APPROVED DESIGN

Amendments

SIDE ELEVATION

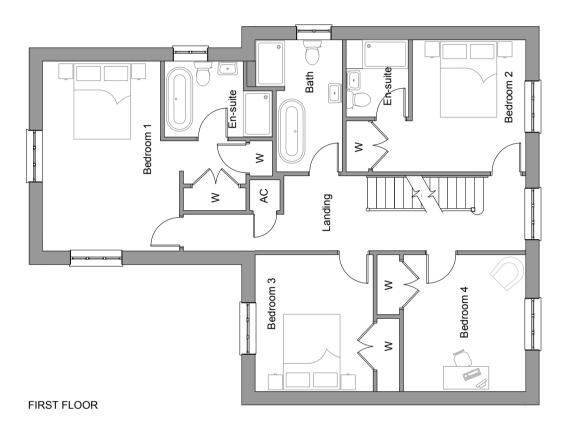
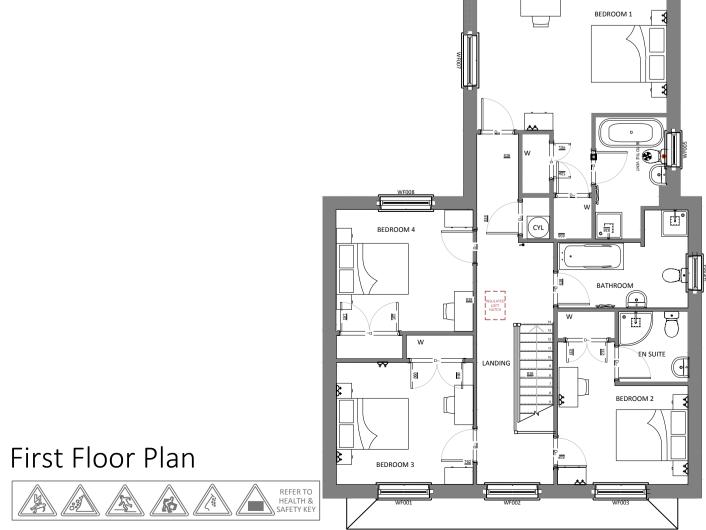
Headers and cill design changed.

Chimney and fire place removed.

Patio doors to kitchen gable end changed
